Date: **August 6, 2001**

Subject: **PART REGISTRATION—POWER
THERMISTOR**

Figure 1

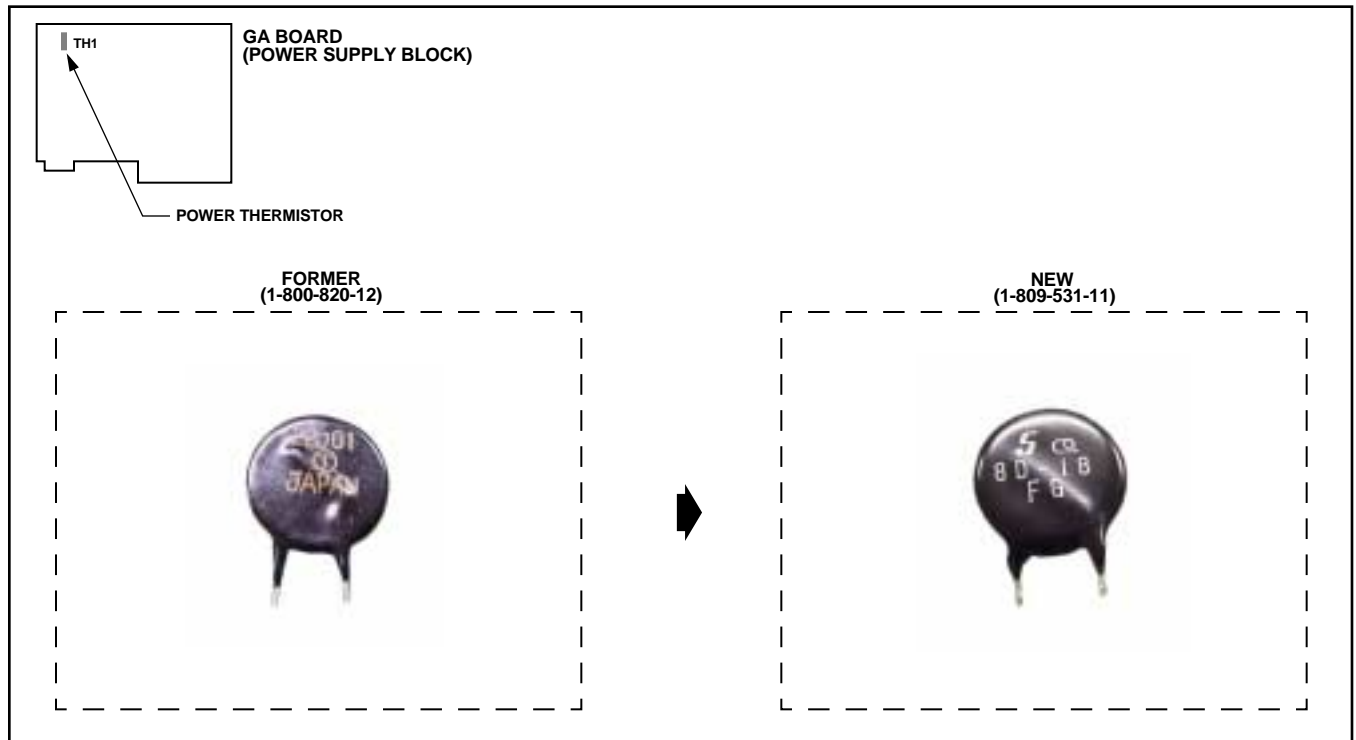
A new power thermistor (TH1) with enhanced reliability, used in the power supply block (GA board), is now available. (See Figure 1.)

**Power Thermistor
1-809-531-11**

Replace the former power thermistor (1-800-820-12) with a new one during scheduled maintenance or repair.
